**RE: Proposed M7 billboard signage - DA No. 60.1/2013
Amended Development Plans and Traffic Summary for Site/Sign 3**

ATTACHMENT A

Site 3

Site 3 - Site Plan & Access

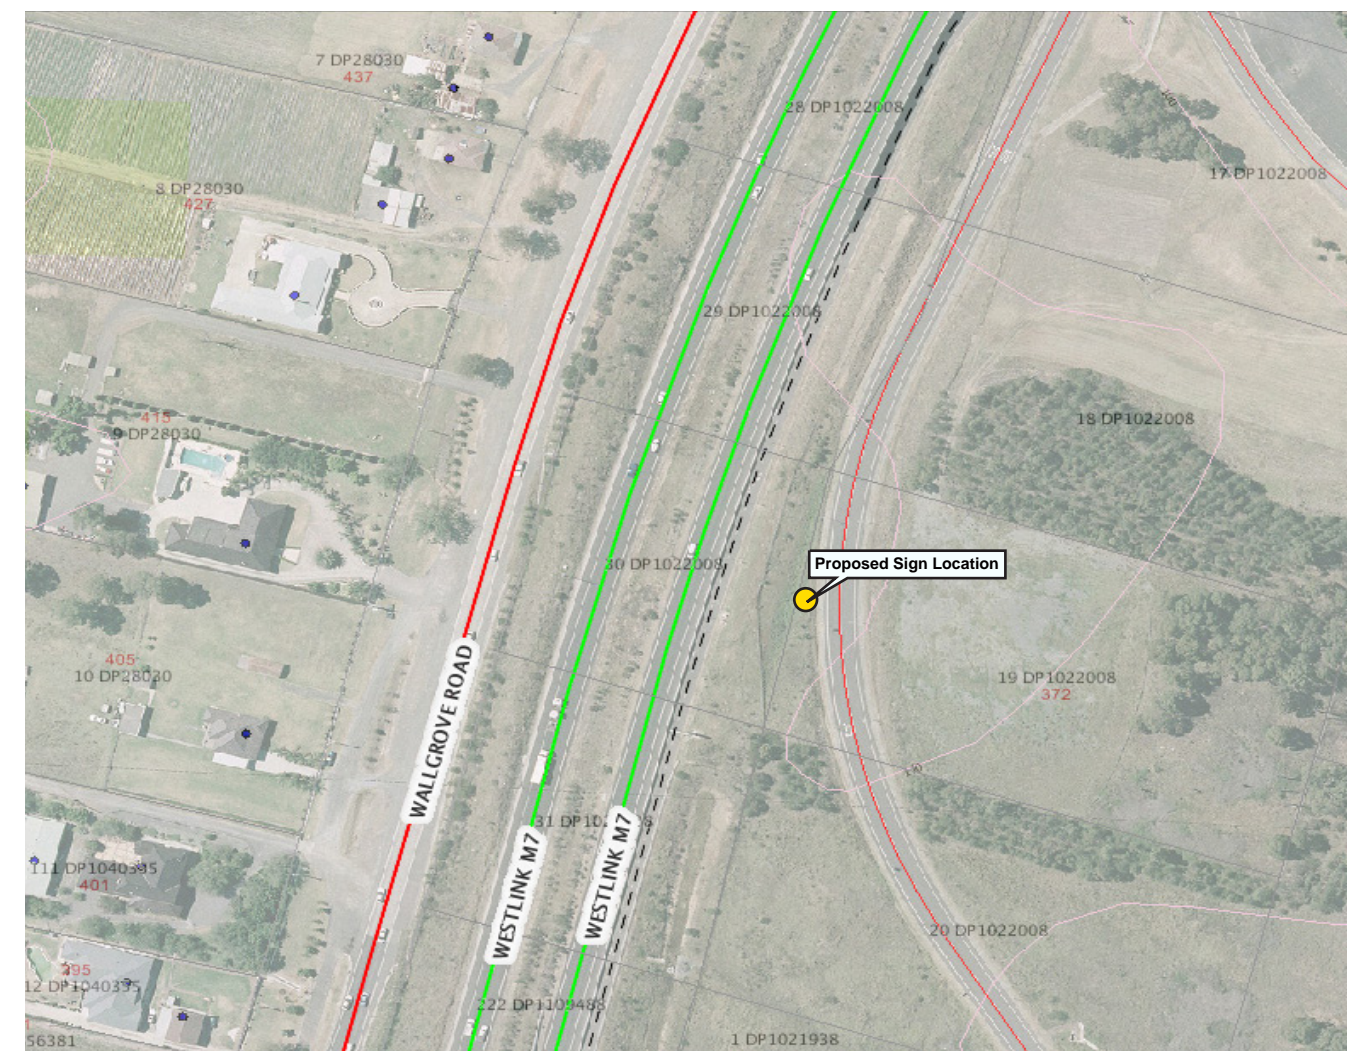
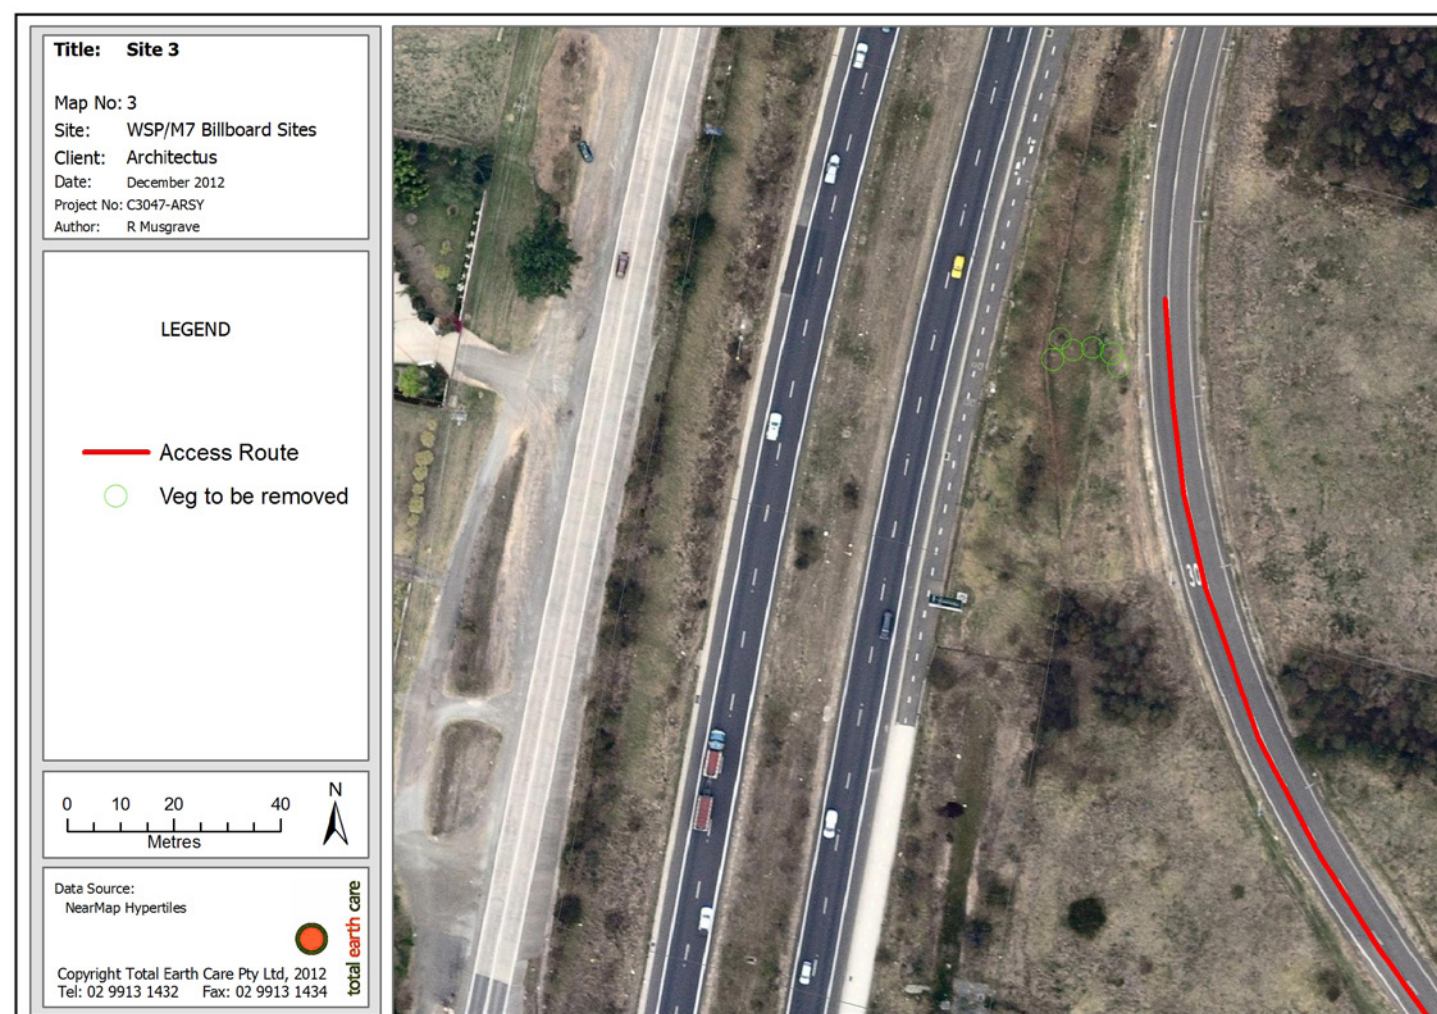
Sign 3 has been relocated 9 metres east of its location shown in the DA that is with Council, to be completely within Lot 19 DP 1022008, Horsley Park. The access road to the equestrian centre is not a dedicated road, and is on land owned by the Trust, and so the proposed sign now spans the road with a clearance of 11 metres under the visual display area of the sign. Note that relocating the sign 9 metres east necessitates raising the sign 3 metres in height (above the M7 road surface) so that it can be completely visible above the motorway embankment from the M7 motorway. The size of the sign (visual display area) remains the same.

Note that Sign 3 could not be moved south within Lot 19 DP 1022008 due to an existing RMS/M7 directional sign that is located south of the proposed sign's existing location.

Site 3 - Plans & Sections

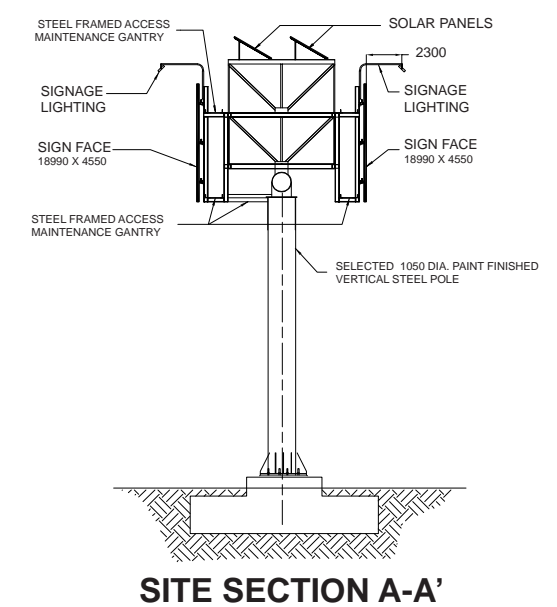
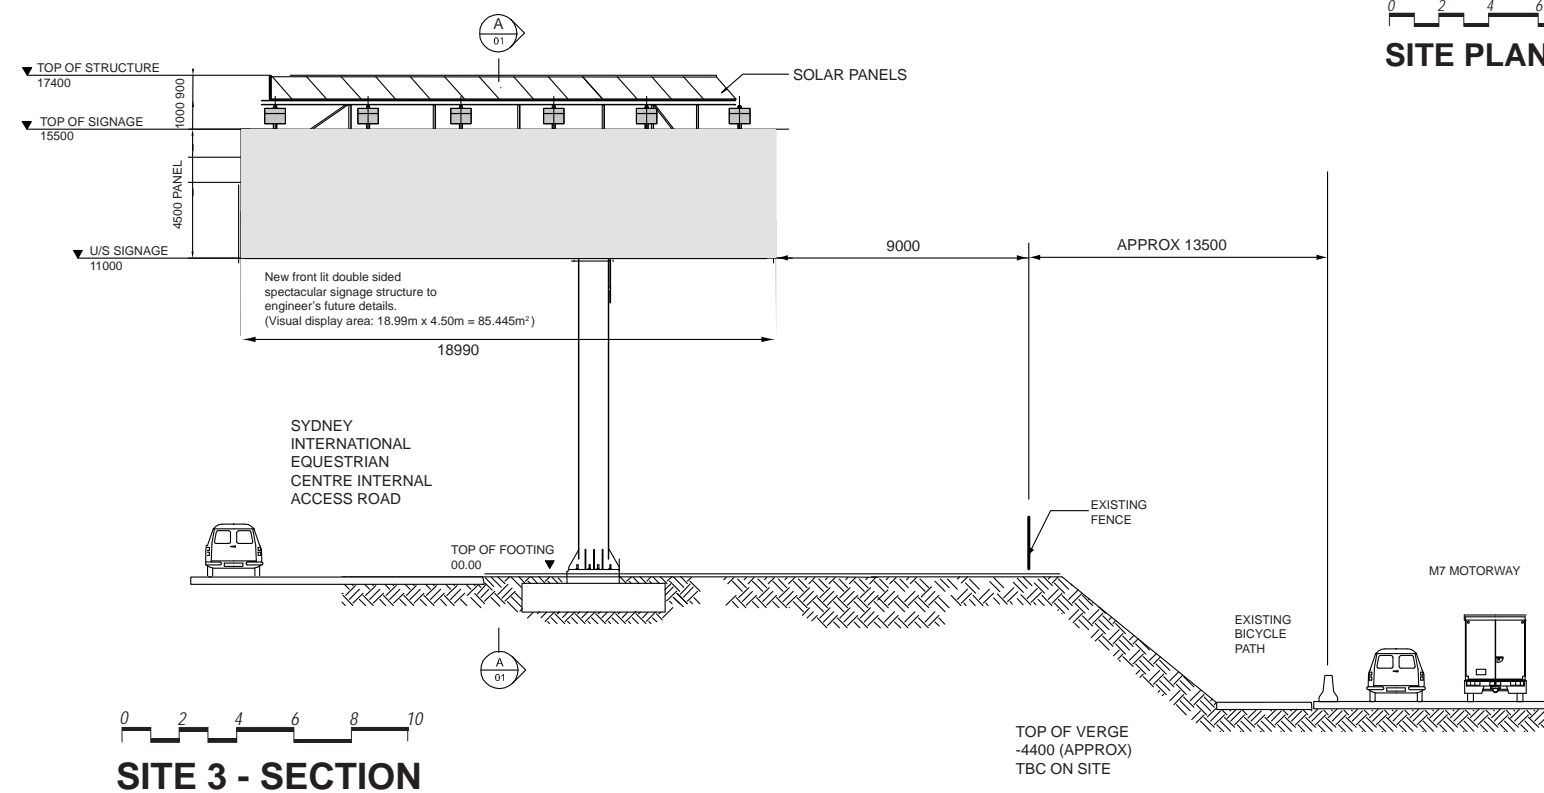
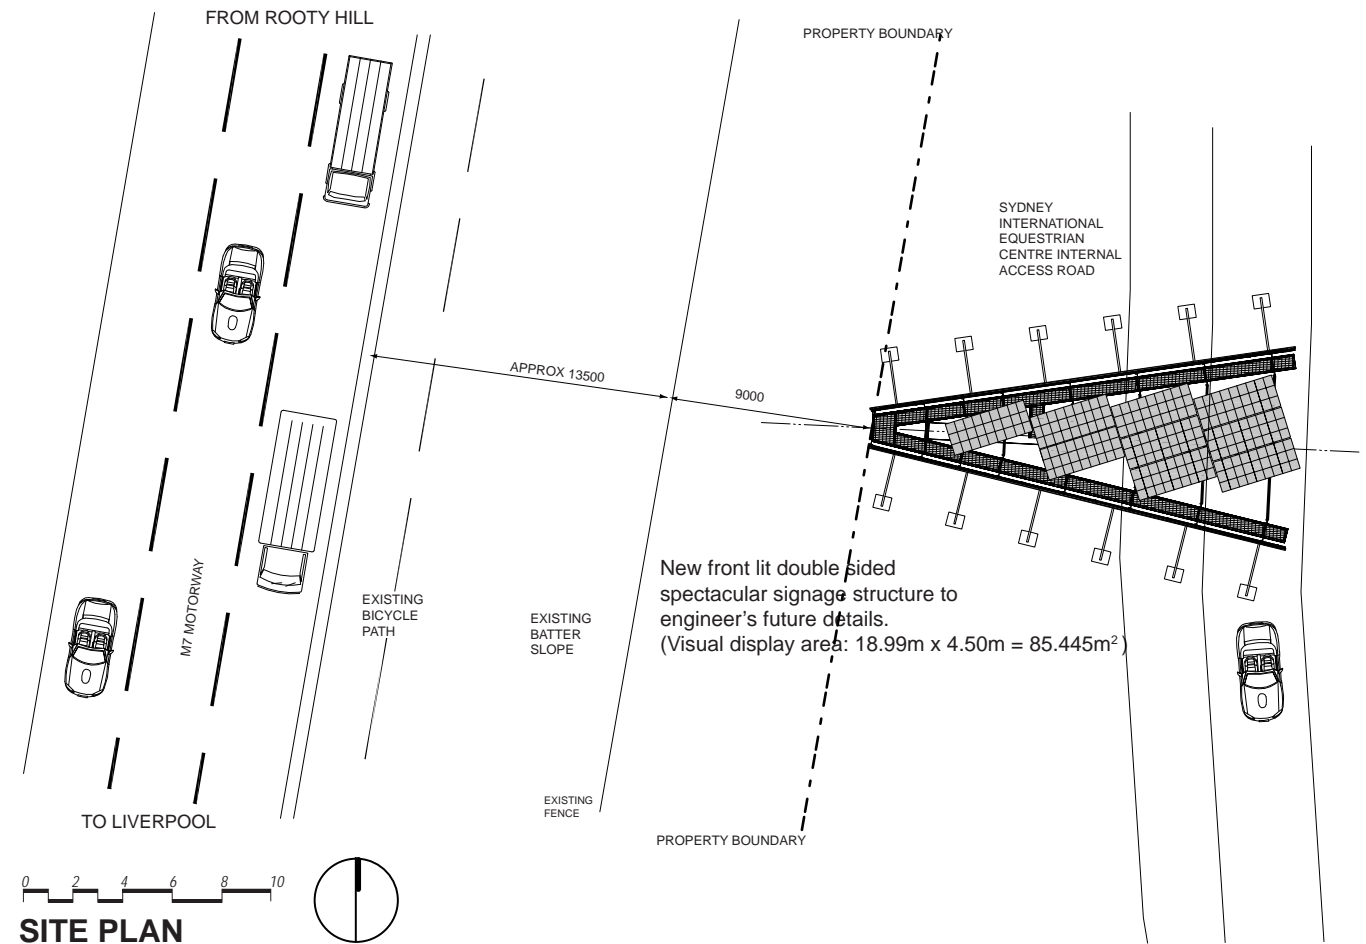
The relocation of the sign will see the proposed sign's footing being sited to one side of the access road to the equestrian centre. The new footing location will not require the removal of any additional existing trees. Furthermore, the relocation of the sign will not see its placement in an ecological significant or sensitive area.

Site 3 - Traffic Safety Summary

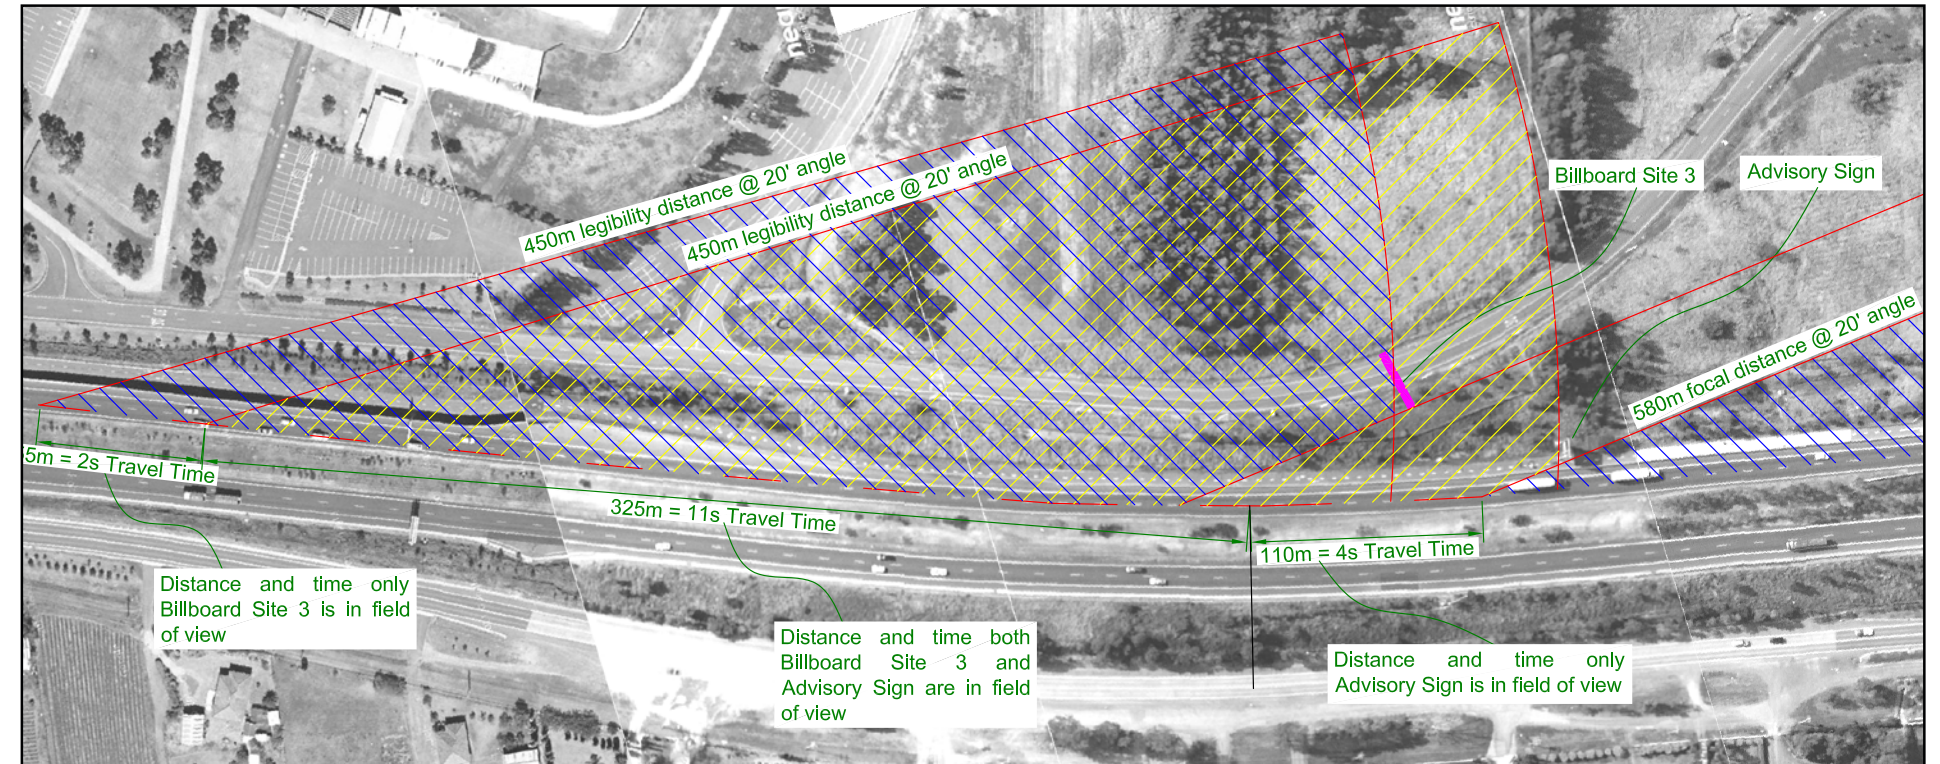
- Site 3 is located about 40 metres prior to (north of) an existing advisory sign advising that it is two (2) kilometres to the Elizabeth Drive southbound off-ramp.
- The information on the advisory sign is considered to be of 'middle-order' importance because no immediate decision is required of the driver. In addition, it is noted that there are supplementary signs to the Elizabeth Drive off-ramp at a distance of one (1) kilometre and also at the off-ramp.
- The cone diagram shows that Site 3 would be legible for 13 seconds and the advisory sign would be legible for 15 seconds. In addition, the cone diagram shows that Site 3 would exit a southbound driver's field-of-view at a point about 110 metres in advance of the advisory sign, ensuring that drivers would view it solely for a period of about four (4) seconds.

- Site 3 is located 280 metres beyond (north of) an existing advisory sign; however, the cone diagram shows that the legibility distance to Site 3 would only overlap with the legibility distance for the advisory sign for about 115 metres, or the equivalent of four (4) seconds travel time.
- Site 3 is also about 370 metres prior to (south of) an existing VMS; however the cone diagram shows that Site 3 would exit a northbound driver's field-of-view at a point about 450 metres in advance of the VMS, ensuring that drivers would view it solely for a period of up to 15 seconds.

- The billboards for Site 3 will be cantilevered across the existing Equestrian Centre access road. The billboards will be directly within a driver's field-of-view as they negotiate the access road; therefore, having consideration for the access road's 30km/h posted speed limit, it is considered that the billboards will not distract drivers to the extent that it creates a safety issue. The other consideration is headroom clearance. Austroads states that most roads (such as the subject access road) require a minimum headroom clearance of 4.6 metres and it is noteworthy that 'very high clearance routes' require 6.5 metres. Having regard for the 11 metres of headroom clearance that will be provided, the proposed Site 3 billboards will not raise any headroom clearance issues for vehicles using the access road.

Viewing Cones - Southbound

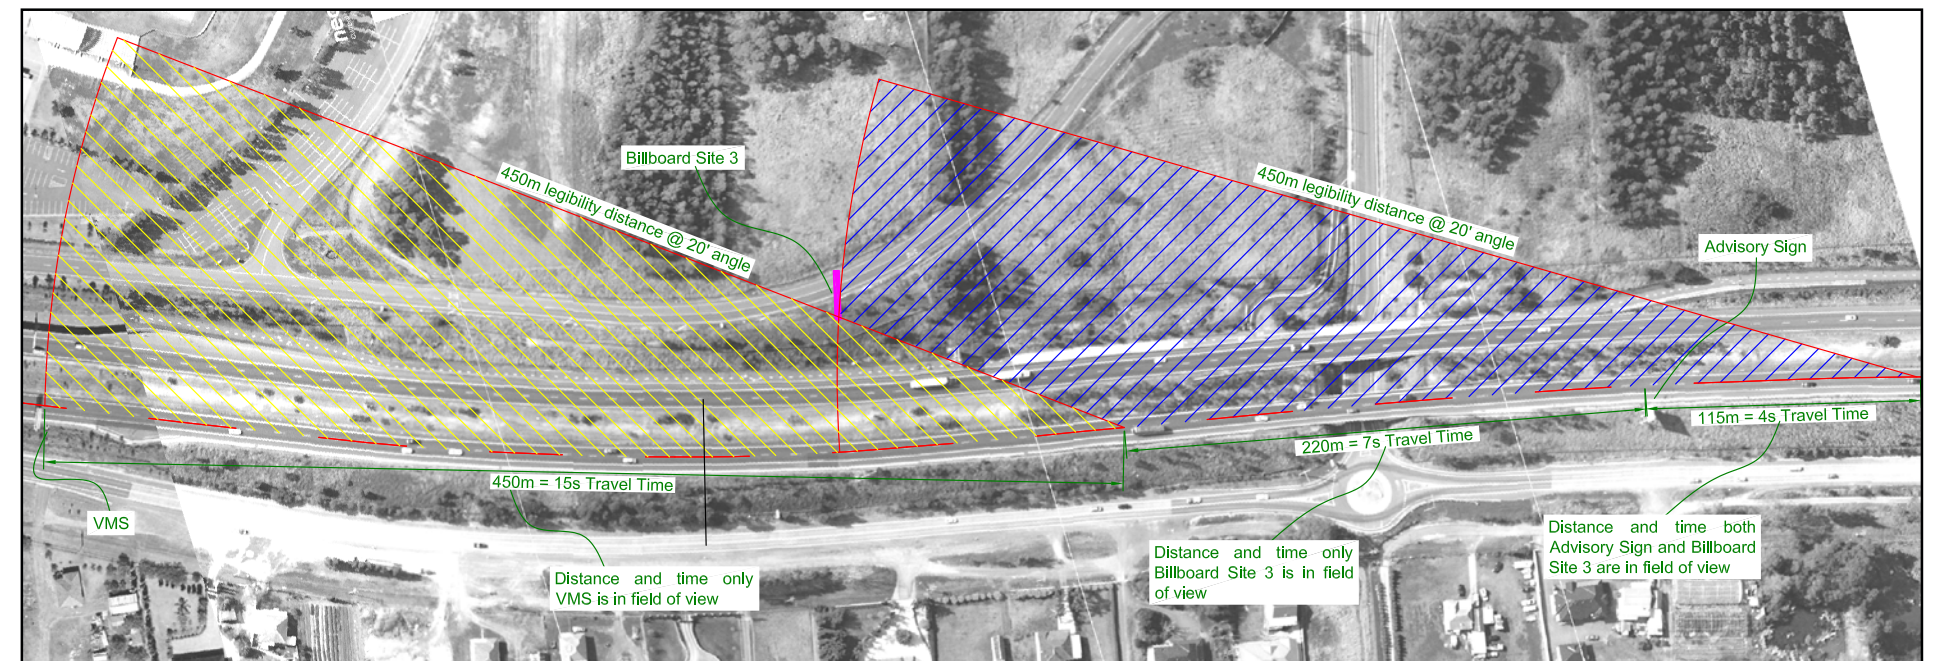
- In summary, the assessment above, including the cone diagrams opposite, shows that Site 3 (with regard to southbound and northbound traffic) is located in a position that is within a driver's field-of-view. Furthermore, its location would not reduce the effectiveness of the existing VMS or advisory signs, nor does its location raise safety concerns for traffic using the Equestrian Centre Access Road. Accordingly, Site 3 is considered acceptable on road safety grounds.
